**CITY OF LOVELAND VISUAL ARTS COMMISSION
MEETING MINUTES
THURSDAY, JUNE 14, 2012 5:00 p.m.
LOVELAND MUSEUM/GALLERY AUDITORIUM**

Mehaffey Park Design Concepts Presentation – Robert Tully / Janet Meisel-Burns: Janet provided the VAC with a thorough update of the Mehaffey Park Project. Key highlights are below:

Robert Tully Art Design Concepts: Robert Tully presented the following PowerPoint presentation for the commission:

ART PROPOSAL:

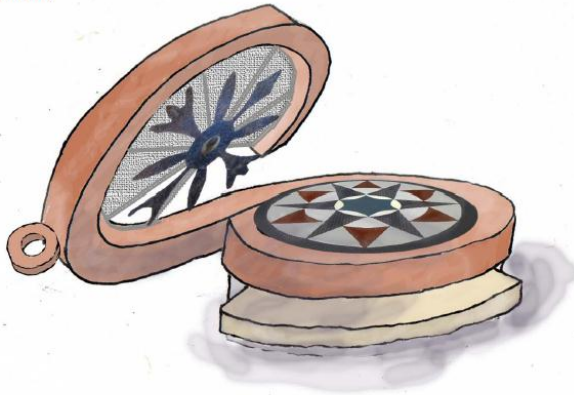
- Foundations included in art budget
- Post caps eliminated and mosaic wall reduced from 7 x18 to 6 x 16'
- Bench design revised with armrest but benches would be an option not included in the art budget. Concrete texturing also would be an option.
- Column 12' high and more inset marble but no detailed carving. Sandblasted wording for Overland Trail added to column.

Compass Rose: Design Team's first choice is 12' circumference piece in order to have a presence within the scale of the park. It is an original and whimsical concept that speaks to the trek west. Exact placement is to be determined. They also like the full-circle benches-- preferably two benches as shown in the presentation.

Mosaic Wall: They like the concept; however, the backside feels unfinished. There is a potential for graffiti on the wall as it provides a large "canvas." The mosaic wall in the visual line (of the Trail) is a nice concept. They want more research on how to make backside more attractive and graffiti-resistant.

- Sherri suggested Robert come back with final recommendations.
- Develop the backside of the Mosaic Wall with additional choices (stone veneer, bands of color discussed). Poem, additional historic context, concrete form liner with way-finding devices, or same mosaic on both sides could be explored.
- VAC desired a final budget for the mosaic wall (with recommendations).

OVERLAND TRAIL REFLECTION MARKER

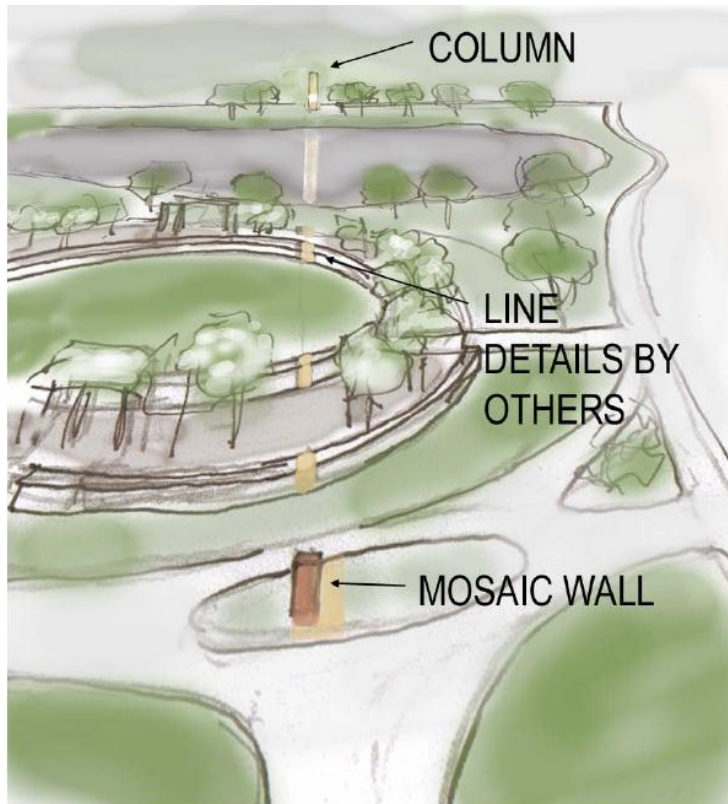
Stone Column: This stone column is to be placed at the 22nd Street Entrance. It is a simple structure 12' tall made of blocks of limestone with white marble. Column made from lighter stone to capture the eye in reflection in the retaining pond. There will be script indicating it is a marker of the Overland Trail. The piece will be 12' square placed onto a concrete foundation. Stainless steel pipe runs through the sculpture. The column is made of heavy stone but has a delicate feel.

Stone Column at 22nd Street: They liked reflection in the retaining pond and felt it would become an iconic marker for the park.
